1. Differences between antenna setup,

Top view of the antenna plate ID ISC.ANT1710/690 Crystal Gate Wave

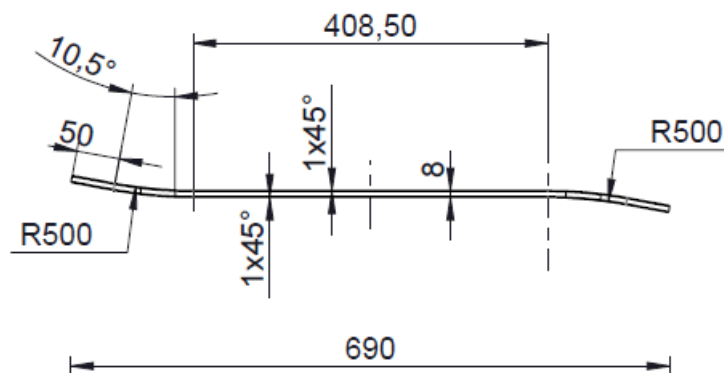
- **ID ISC.ANT1710/690-A Crystal Gate (current antenna)**
- **ID ISC.ANT1710/690-A Crystal Gate Wave (new antenna)**
 - We changed the total dimensions of the antenna plate from 1700mm x 682mm (ID ISC.ANT1710/690-A Crystal Gate) to 1488mm x 690 mm (ID ISC.ANT171/690-A Crystal Gate Wave).
 - We changed the shape of the acrylic antenna plate. The new antenna ID ISC.ANT171/690-A Crystal Gate Wave has an "S" shape. The current antenna ID ISC.ANT1710/690-A Crystal Gate uses a "Z" shape.
